ROCHESTER GAS AND ELECTRIC CORPORATION • 89 EAST AVENUE, ROCHESTER, N.Y. 14647

August 5, 1976

This letter is in response to your letter of June 24, 1976, which requested additional information regarding our proposed spent fuel pool modification. Enclosed please find the responses to your questions and the responses to the Staff's questions resulting from the May 21, 1976 meeting between the NRC Staff and RG&E.

Figure 15-1

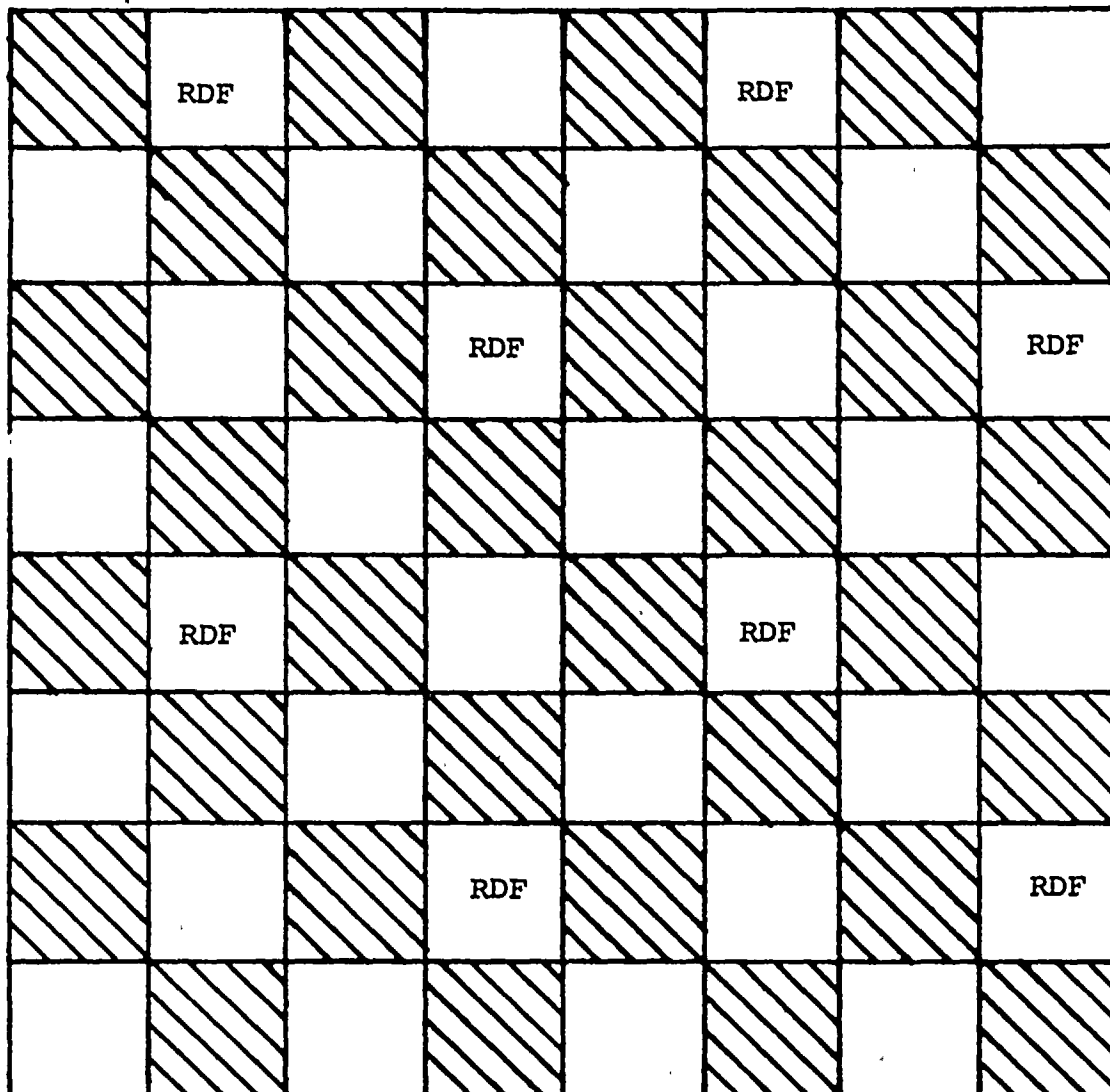
Question 15 The proposal to increase the storage capability of the spent fuel storage pool from 210 fuel assemblies to 595 appears to change the possible consequences if an object such as a tornado missile or dropped crane load impacts on the stored spent fuel. Provide the following additional information:

- (a) What consideration has been given to reducing the probability or consequences of a tornado missile impacting on stored spent fuel?

RESPONSE: The consequences of a postulated missile impacting stored spent fuel in the proposed racks (595 locations) has been decreased below that of the existing racks (210 locations) by preventing the fuel assemblies in the latest discharge batch from being all grouped together.

The fission product density is greatest in fuel assemblies that have the shortest cooldown time, assuming similar irradiation. Therefore, the stored fission product density can be reduced by surrounding a recently discharge fuel assembly with fuel assemblies that have been stored for a year or more. Figure 15-1 illustrates a section of the proposed spent fuel storage racks with the recent discharge stored as illustrated. The remaining storage locations were assumed to be filled with fuel assemblies that have been out of the reactor for one year (See Figure 15-2).
